# Access Compliance Report

## Public Rights-of-Way

### (Curb Ramps)

Intersection ID: 8522	Main Street: MARBLE_ST	Cross Street: WILLARD_ST	Location: NE
ADA ID: 3A1BE1839151	Ramp Type: Directional1	Initial Pass/Fail: Fail	Overall Compliance: No
Severity Score: 12.5			
Codes/Mitigation Info/Possible Solution		Field Measurements/Component Compliance

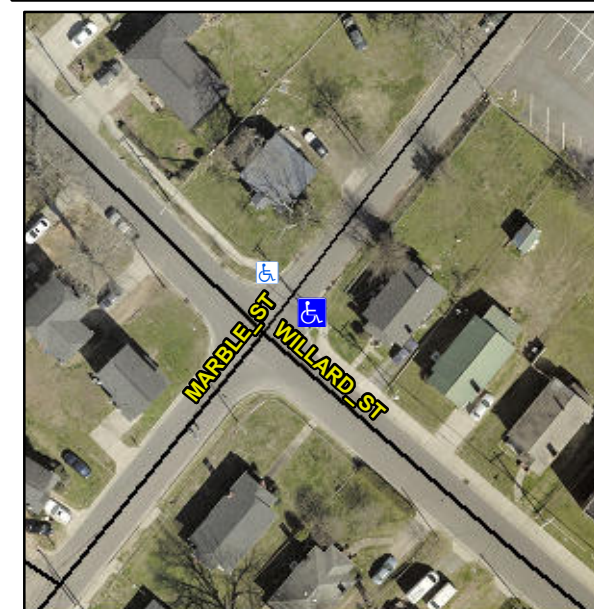
**Remove & Replace Entire Ramp.**

**R304.2.2**
